INSTRUCTIONAL BULLETIN NO. 17-09

Regarding Revised Standard Drawings

Effective February 9th, 2018 letting (November 29th, 2017 Turn-in), the following Standard Drawings have been revised. Also, Section 5, Index of Standard Drawings, of the Roadway Design Guidelines has been revised to incorporate these changes.

D-PB-1

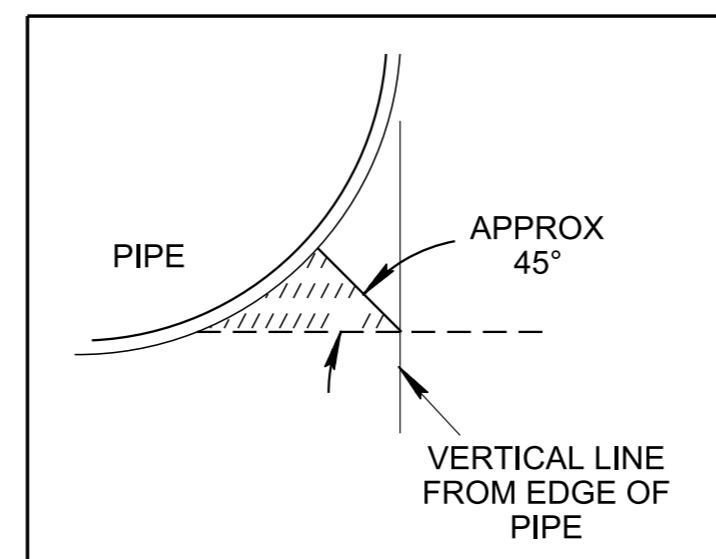
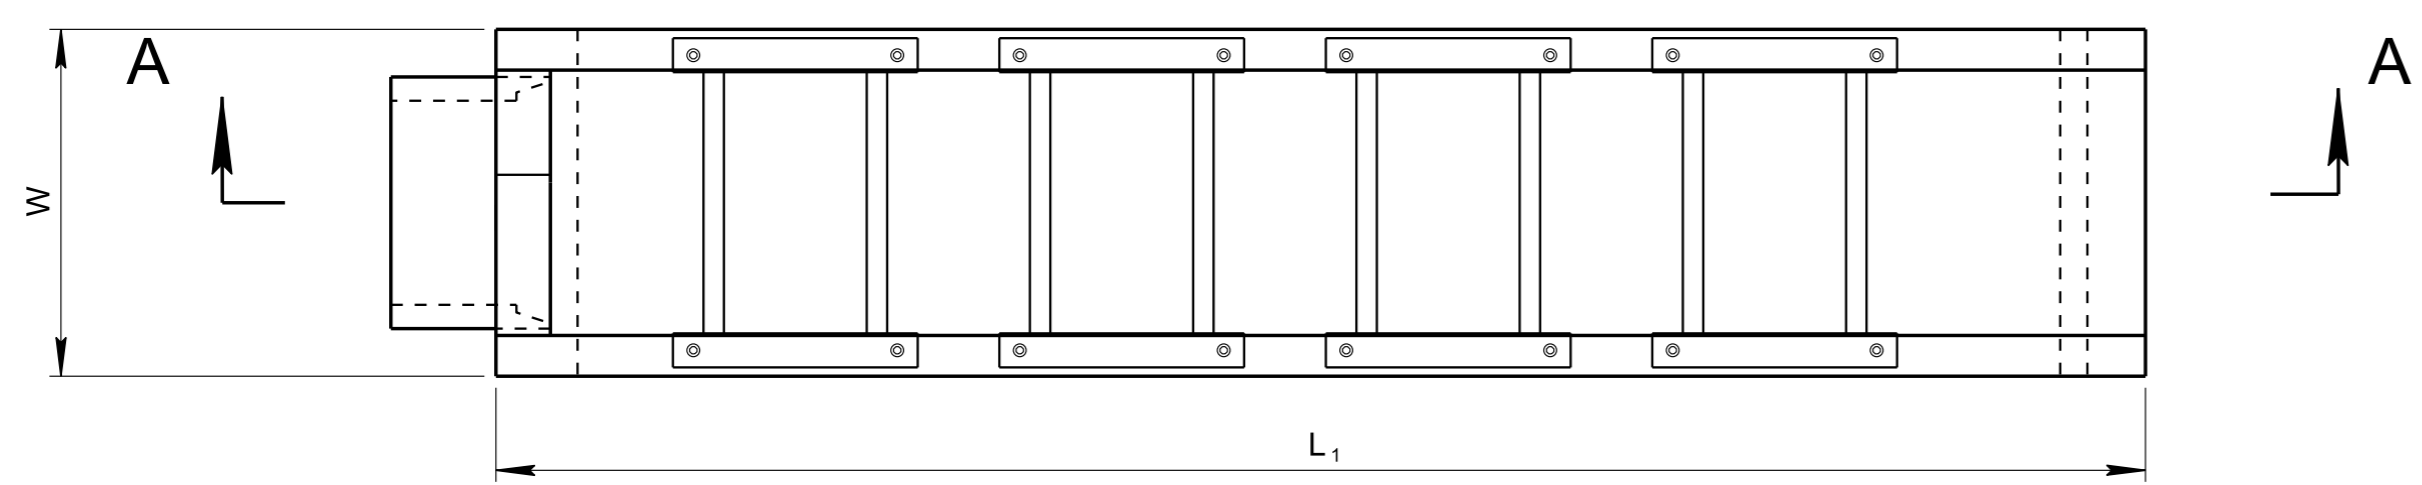
- REV. 7-12-07: REVISED GENERAL NOTE ①
- REV. 6-1-09: REVISED GENERAL NOTE ① AND TITLE NAME. ADDED GENERAL NOTE ①
- REV. 2-1-12: REVISED DRAWING NAME ADDED EFF DETAIL. REVISED GENERAL NOTES AND TABLE. ADDED MINIMUM COVER TABLE.
- REV. 8-21-12: REVISED GENERAL NOTES. CHANGED BACKFILL MATERIAL.
- REV. 1-2-13: REVISED TRENCH DETAILS REVISED BEDDING TABLE.
- REV. 3-16-17: CLARIFIED PAYMENT ITEM NO. IN TABLE B.

**SIDE DRAIN CONCRETE
ENDWALL WITH
STEEL PIPE GRATE
FOR 15" THRU 48"
PIPES - 6:1 SLOPE**

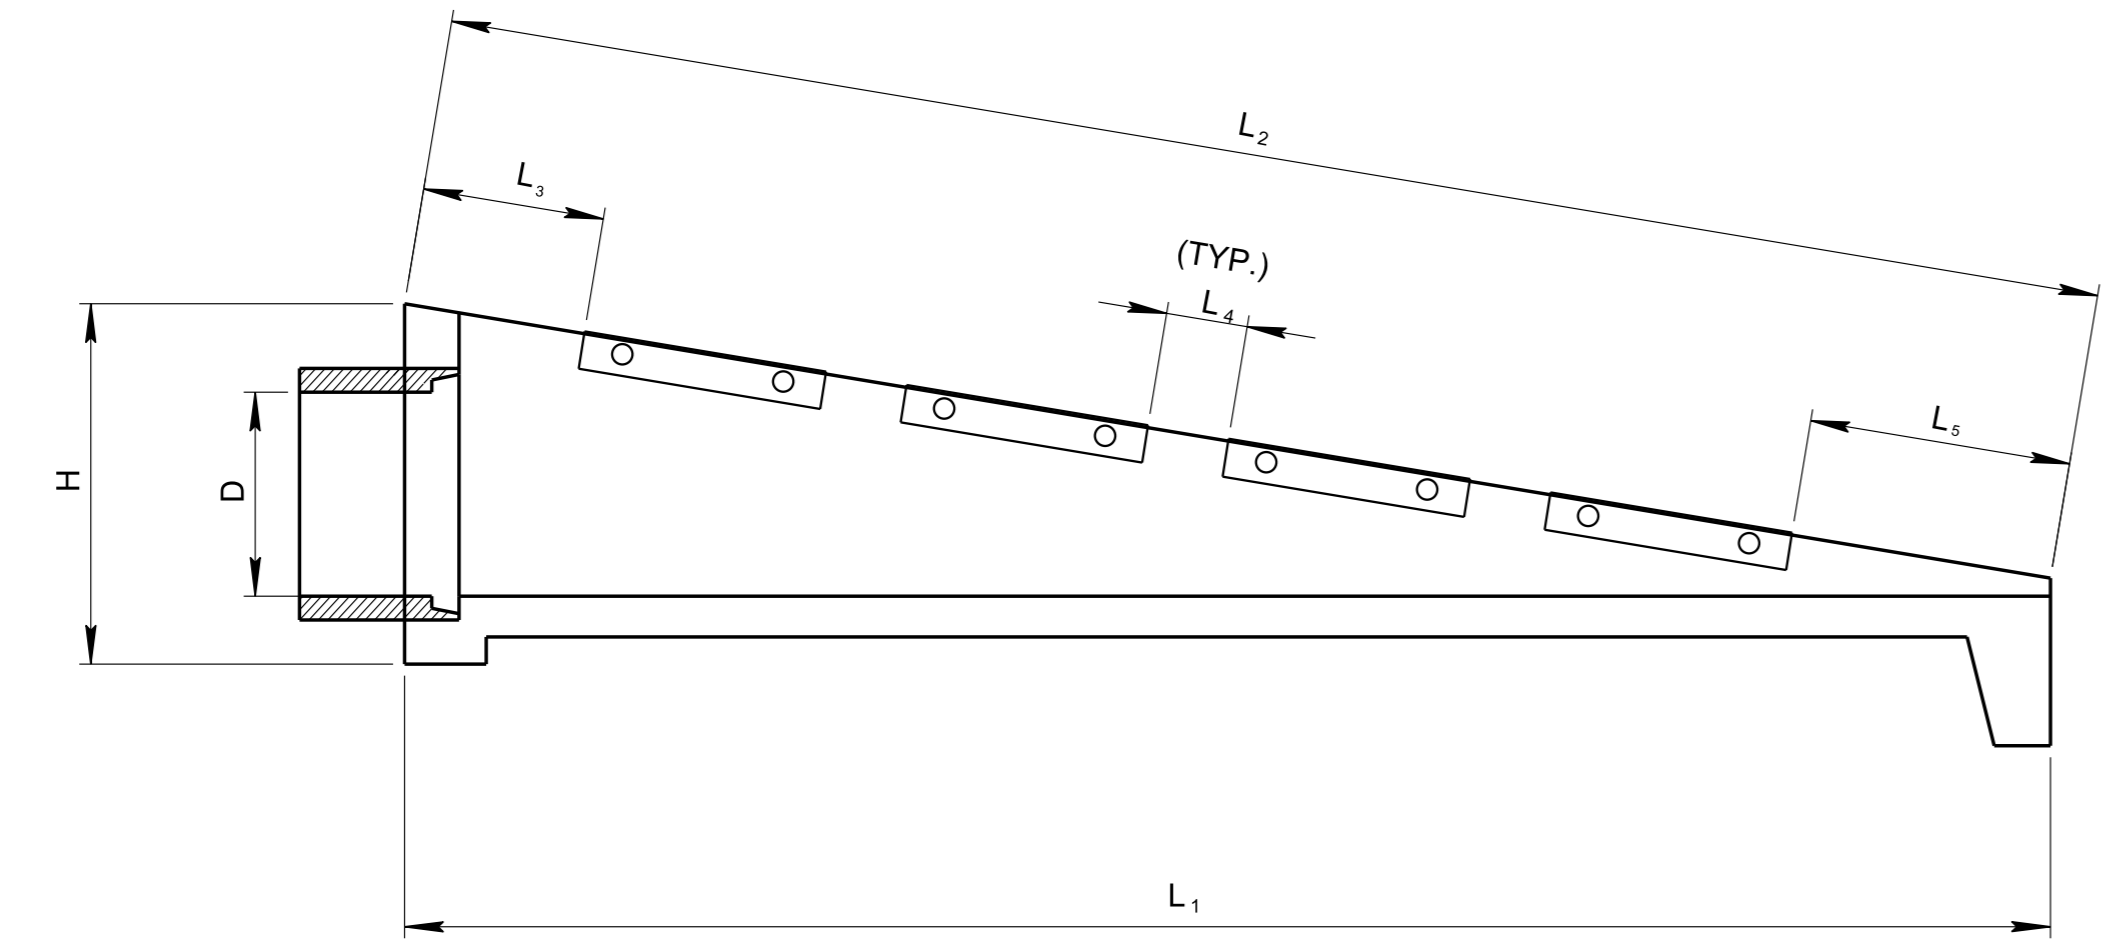
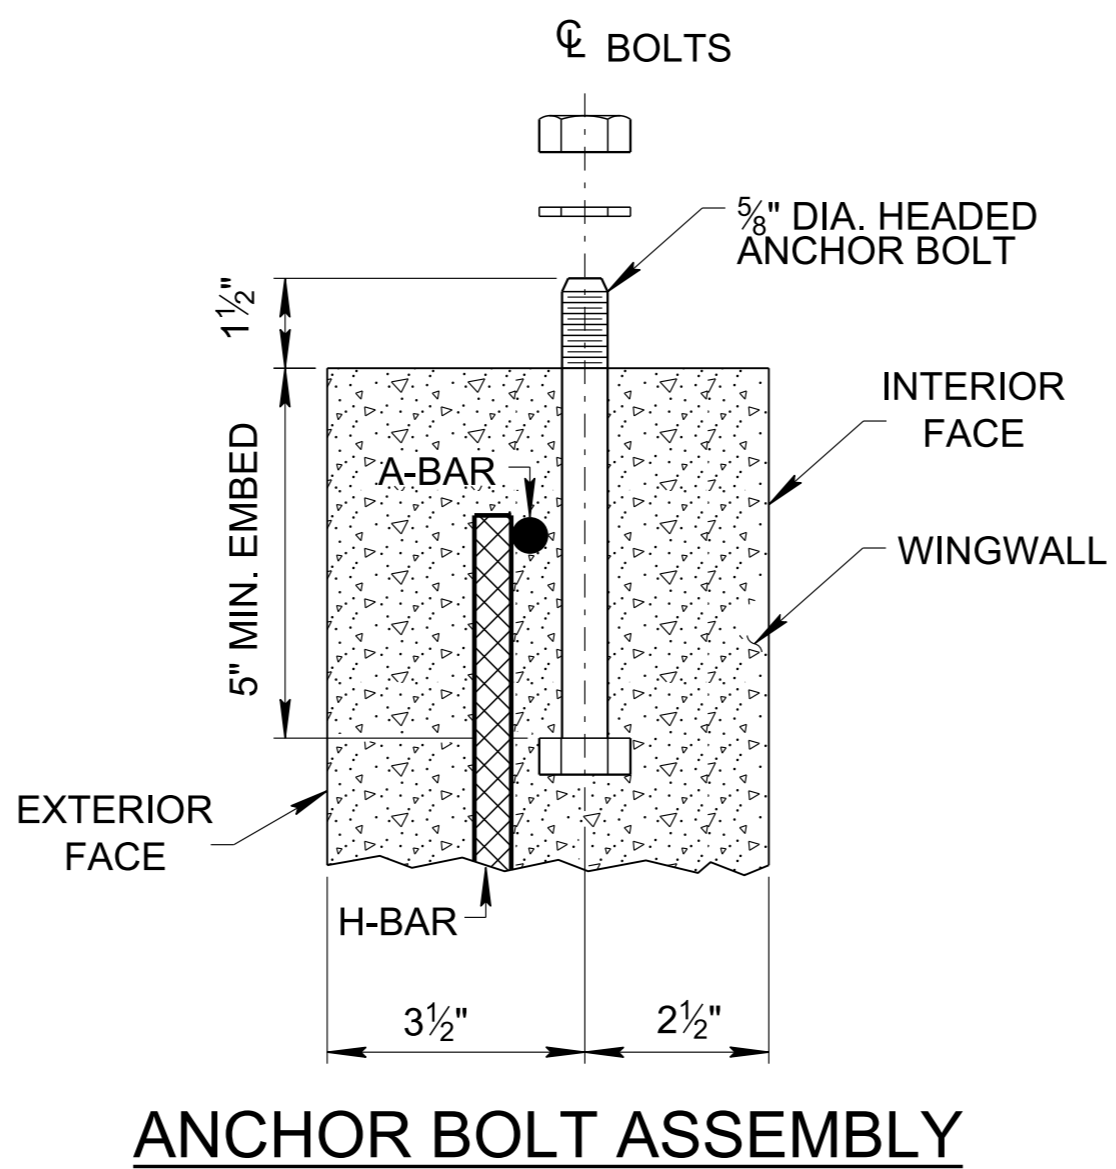
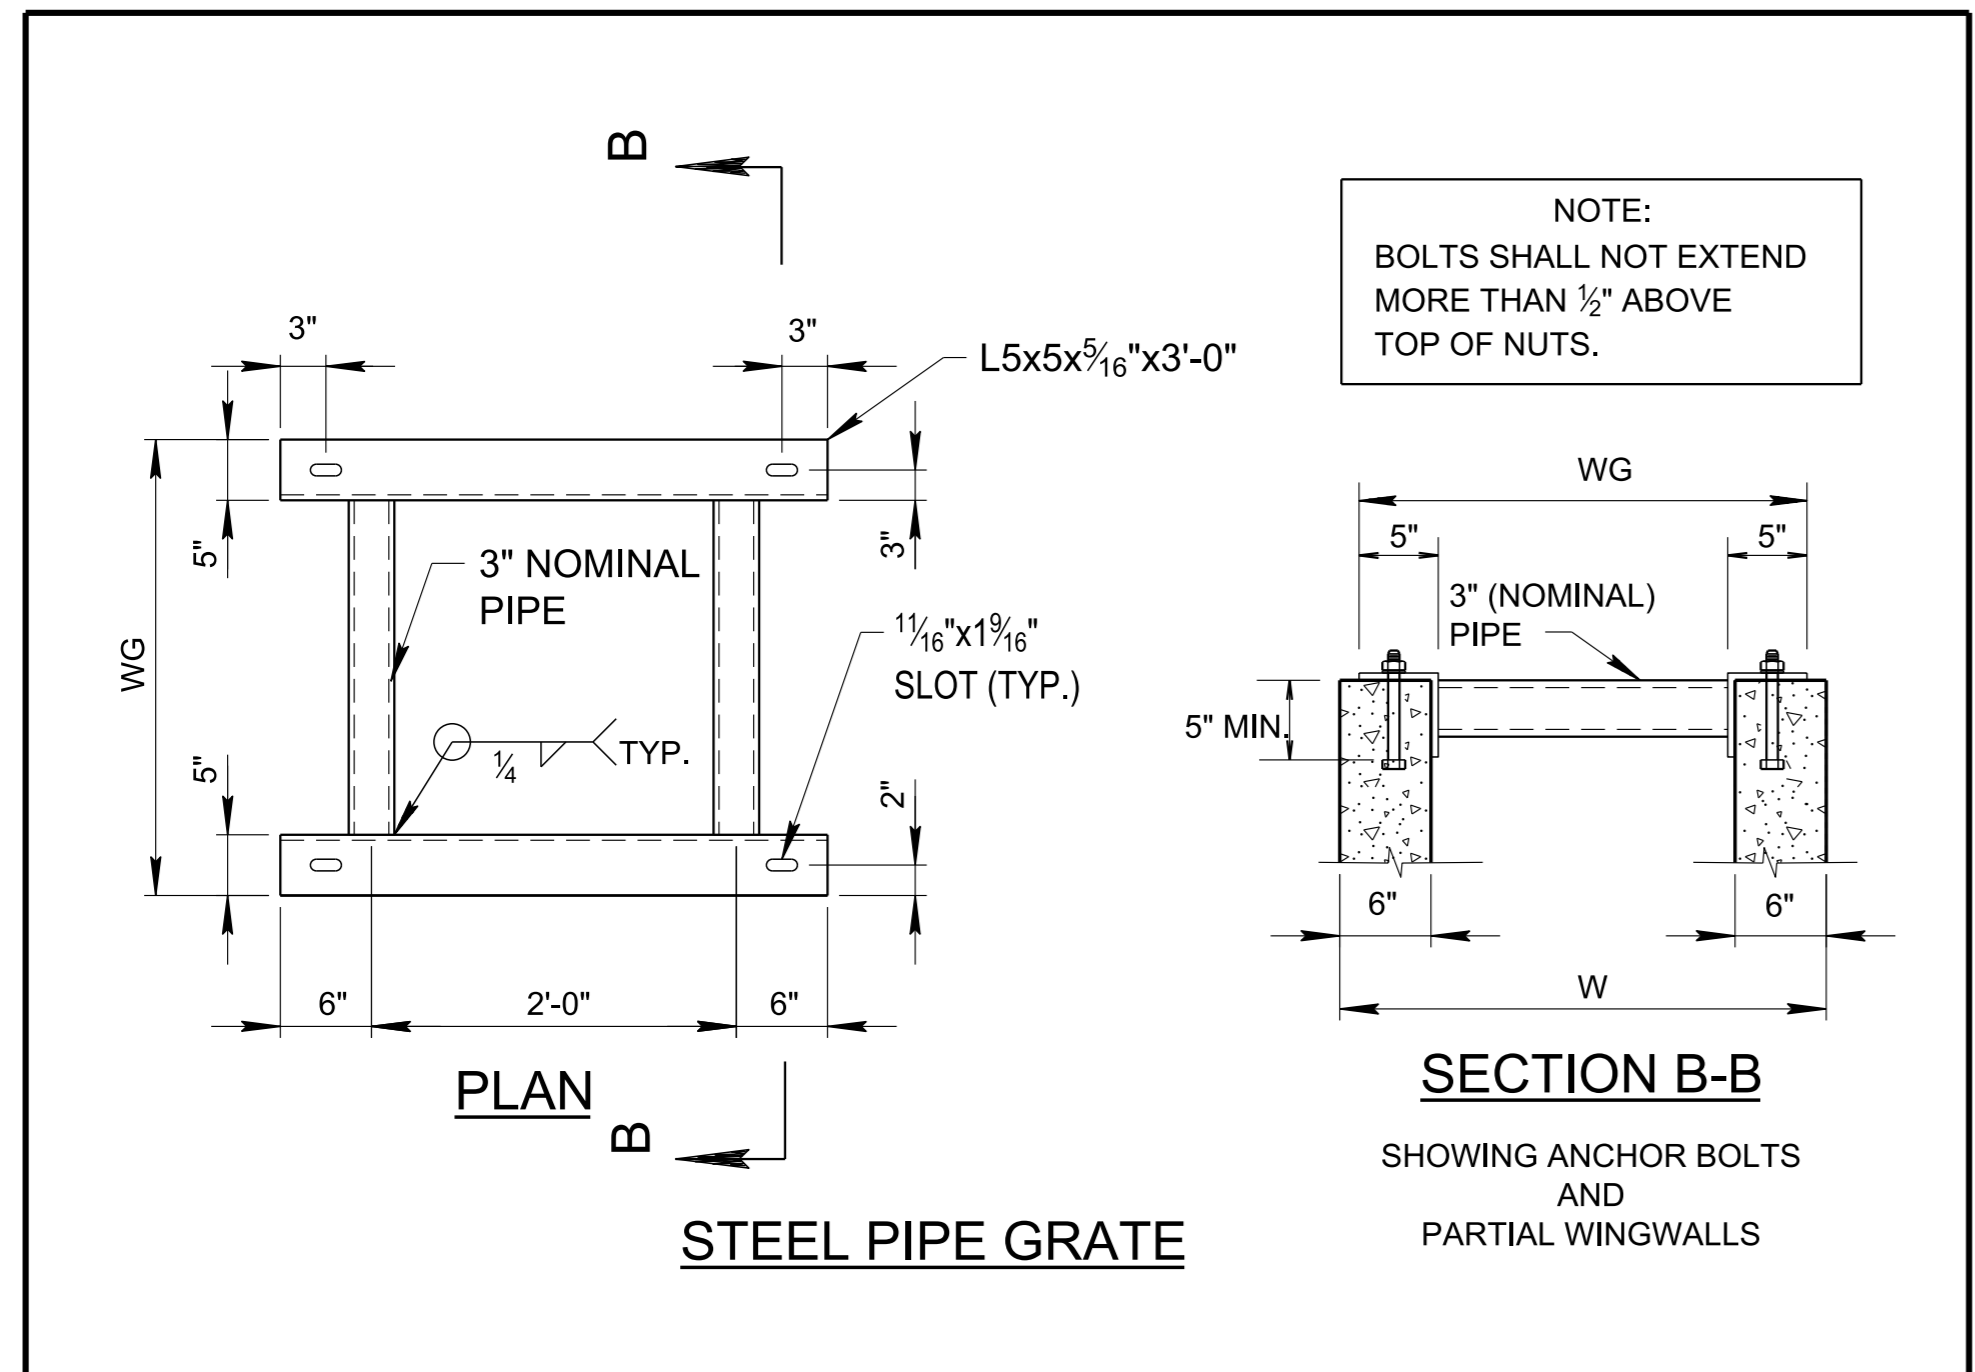
□ REV. 3-16-17: REVISED GENERAL NOTES. ADDED FOOTNOTE TO TABLE.
